A REPAIR

## ON-SITE SEWAGE DISPOSAL SYSTEM HOWARD COUNTY HEALTH DEPARTMENT BUREAU OF ENVIRONMENTAL HEALTH

ADDRESS: 6605 Prestwick Drive PROPERTY OWNER: Robert McGrath

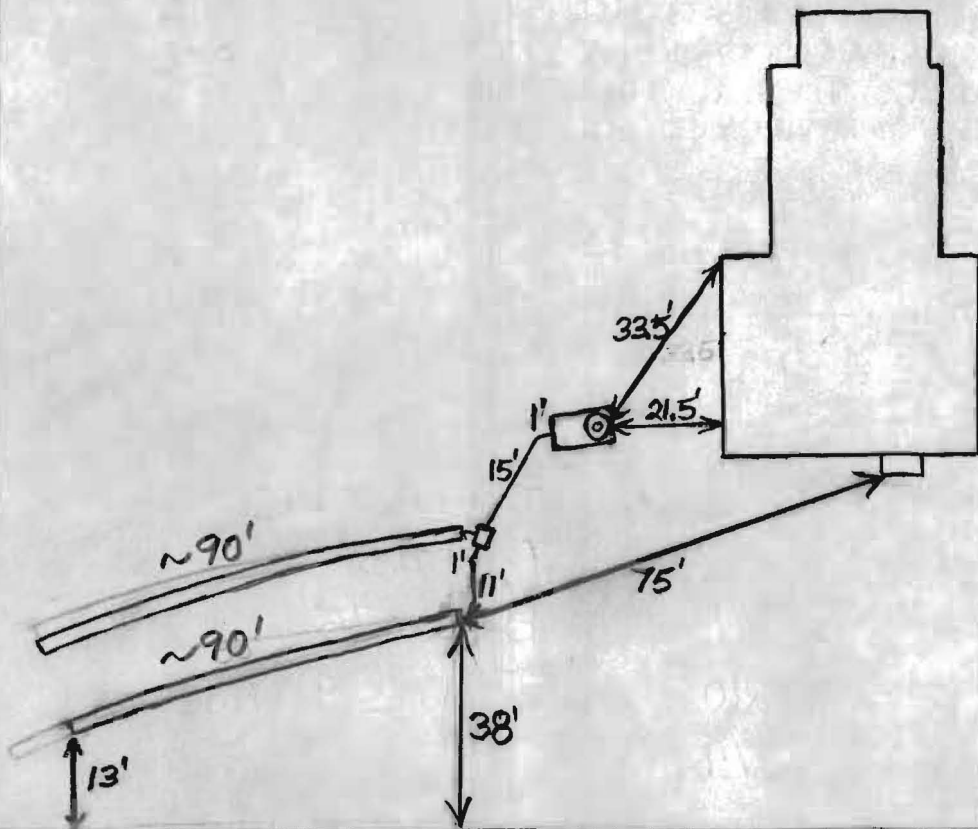
INSTALLATION 11/15/06 Trenches installed. O.K. to backfill.  
 Septic tank has roots in it and will need to be replaced.  
 Homeowner aware of problem and has agreed to install  
 new tank in near future (BB)
